Development Management Sub Committee

**Application for Planning Permission 17/01183/FUL
At 70, 72 Newhaven Road, Edinburgh, EH6 5QG
Demolition of existing commercial buildings and erection of
52 residential flats (as amended units reduced to 49
residential flats).**

Item number	7.2
Report number	
Wards	A12 - Leith Walk (Pre May 2017)

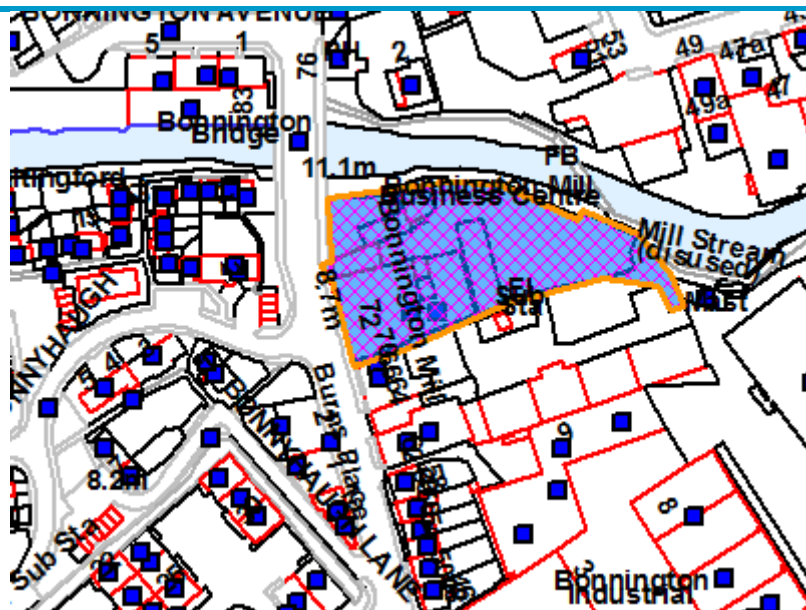
2nd Para - Whilst, we understand that the site is afforded some level of protection from the Water of Leith Flood Protection Scheme there are uncertainties associated with the standard of protection the scheme affords, which also does not appear to fully take climate change into account.

1.7 - If the Council are minded to grant this planning application, we would strongly recommend that mitigation measures are included within the design of the buildings. This could include raising finished floor levels above the FPS and the provision of safe access/ egress. The proposed finished floor levels of the 3 blocks range between 7.75m AOD and 8.525m AOD, which would be above the modelled 1:200 year flood level. Ground levels surrounding the buildings of approximately 7.3m AOD would indicate that safe, flood free access/ egress may be difficult to provide.

CEC comment: The Water of Leith Flood Protection Scheme provides defence to the 1-in-200 event with a 12% allowance for climate change. Also the new development is designed for 1-in-200 + 30%cc.

CEC comment: This paragraph contradicts by saying FFL need to be above FPS, it then says that is what has been designed? CEC has asked for FFL above 7.559m AOD, which is what they have provided.
